Legislative Council Panel on Transport
Supplementary Information Paper on
Widening of Tolo Highway
Section between Ma Liu Shui Interchange
and Island House Interchange
Noise Barriers

Environment, Transport and Works Bureau
January 2003
ETWB(T)4/6/185

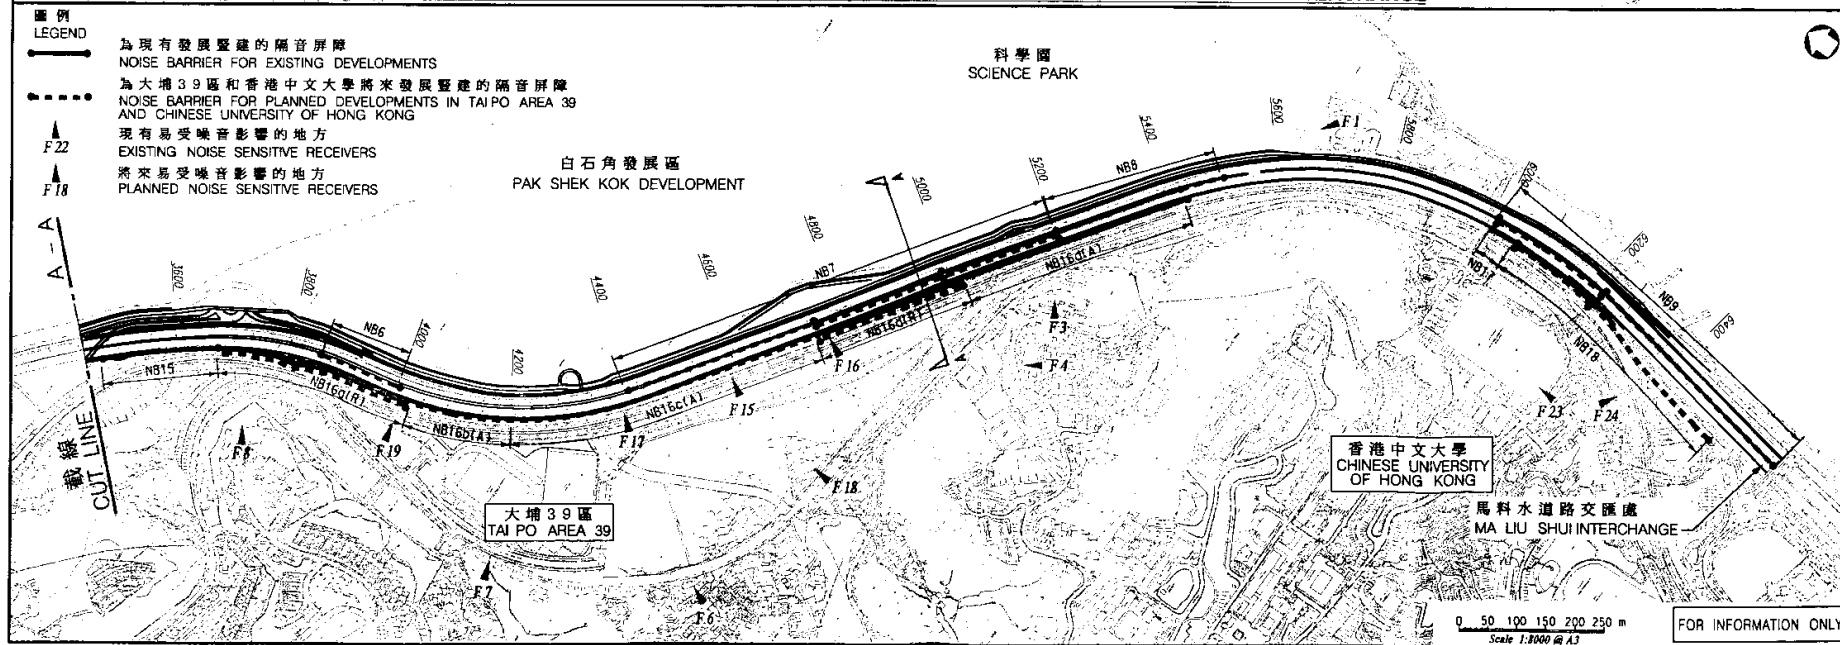
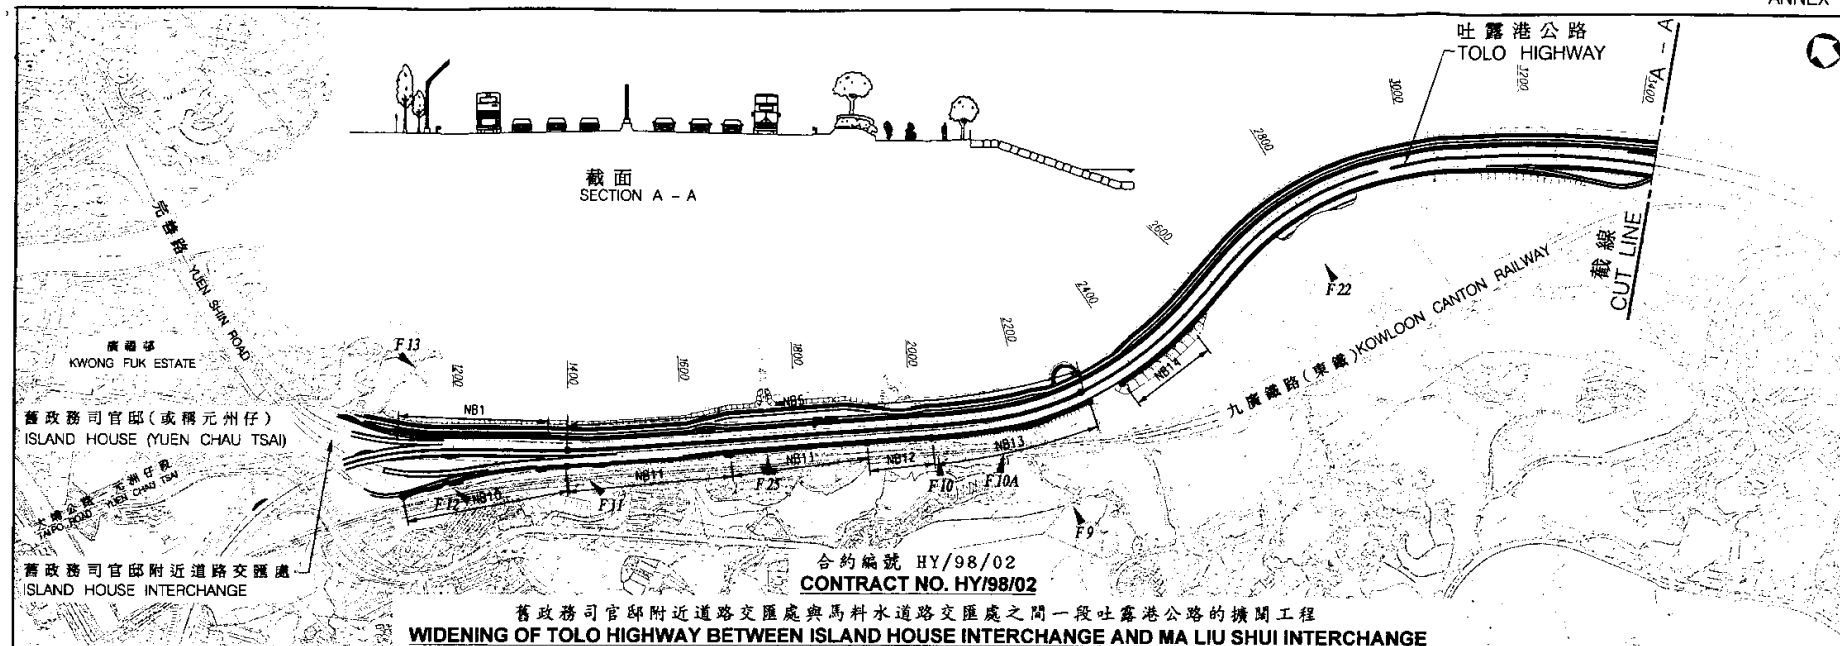
5. We have identified that the length of noise barriers which are solely for planned future developments, is about 1 920 m, i.e., 28% of the total length of the revised noise barrier provision. They are for the planned development at Tai Po Area 39 and at CUHK, and the location of these lengths of barriers is shown on the plan at **Annex A**. According to the principle that the erection of noise barriers should align with the programme of planned developments, the provision of these barriers can be deferred to a later date. For those which have been erected (about 1 470 m fully completed and 450 m with post only), they can be removed.

7. The length of the barriers in this category which have been erected is about 1 460 m (930 m fully completed and 530 m with post only). The location of these barriers is also shown on the plan at **Annex A**. In the section near Tai Po Area 39, it is feasible to remove the upper 1 m to 2.5 m of about 460 m of the vertical barriers in the central median, and the canopy portions together with the upper 2 m of 610 m of the vertical barriers along the kerbside of the north-bound carriageway. In the southern section near CUHK, it is feasible to remove the upper 3 m of about 230 m of the vertical barriers along the central median and the upper 5 m of 160 m of the vertical barriers along the kerbside of the north-bound carriageway.

Modification	Length of barriers (m)	Estimated Cost (\$ million)
(a) Removal of the noise barriers solely for planned developments	1 920	3.5
(b) Trimming down of the noise barriers along kerbsides and central median for both existing and planned developments	1 460	4.5
